UNITED STATES PATENT AND TRADEMARK OFFICE

Office Action Summary

10/516,565

DETAILED ACTION

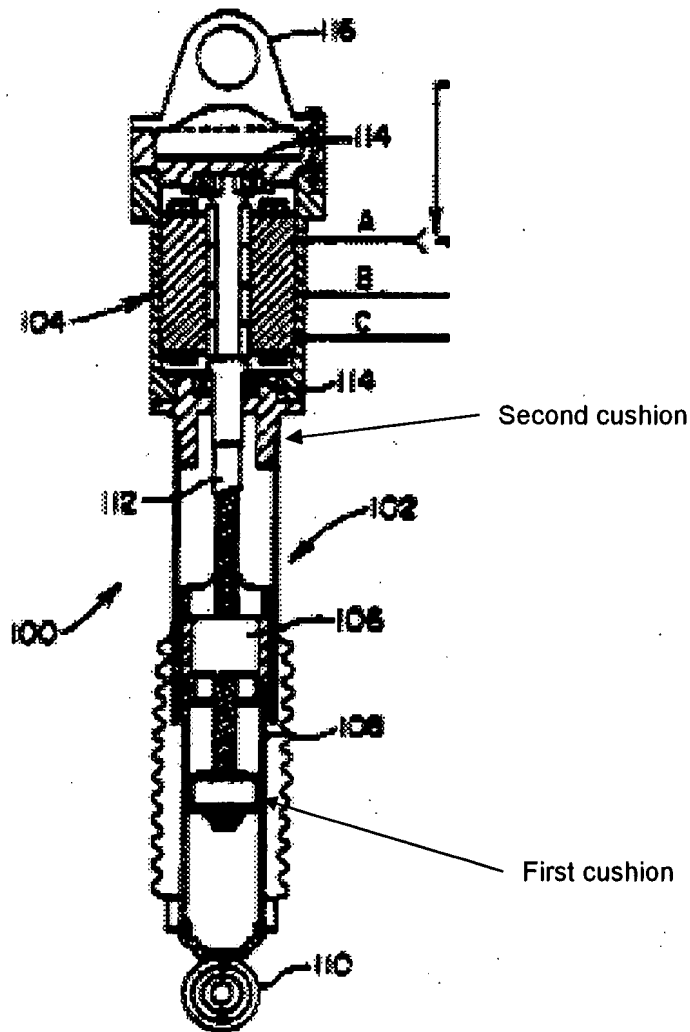
Patil et al. teach an electromagnetic shock absorber comprising: a shock absorber body (104) which makes a telescopic motion in response to an input from outside; a ball screw mechanism which is arranged in the shock absorber body, converts the telescopic motion into a rotary motion, and is composed of a ball nut and a screw shaft (106, 112); and a motor (104) which is provided coaxially with the shock absorber body and generates electromagnetic resistance to oppose against the rotary motion to be input into a rotary shaft of the motor, wherein the screw shaft and the rotary shaft of the motor are constituted as one united shaft member, wherein the shock absorber body has an external cylinder, and an internal cylinder to be slidably inserted into the external cylinder, and the motor is coaxially connected with an upper part of the external cylinder, wherein the ball nut of the ball screw mechanism is fixed to an upper part of the internal cylinder, and the screw shaft which is united with the rotary shaft of the motor is spirally engaged with the ball nut, wherein the screw shaft and the rotary shaft

are connected by an intermediate shaft section which is rotatably supported by an inside wall of the external cylinder through a bearing, wherein a first cushion member which comes into contact with a lower surface of the ball nut at a maximum descent stroke position of the internal cylinder is installed at a lower end of the screw shaft, and wherein a second cushion member which comes into contact with an upper surface of the ball nut at a maximum ascent stroke position of the internal cylinder is installed at a lower surface of the bearing. (See below)

Patil et al. do not teach wherein a diameter of the intermediate shaft section is thinner than that of the screw shaft, and a diameter of the rotary shaft is thinner than that of the intermediate shaft section. Takegawa teach wherein a diameter of the intermediate shaft section is thinner than that of the screw shaft, and a diameter of the rotary shaft is thinner than that of the intermediate shaft section. (Figure 3)

Because both Patil et al. and Takegawa teach screw shafts, intermediate shafts and rotary shafts which are connected, it would have been obvious to one having ordinary skill in the art to provide the shaft of varying diameters as taught by Takegawa since the operation of the shock absorber is in no way dependent on the shaft diameters and one skilled in the art would have known to substitute one shaft for another to achieve the predictable result of reducing the number of components and production costs.
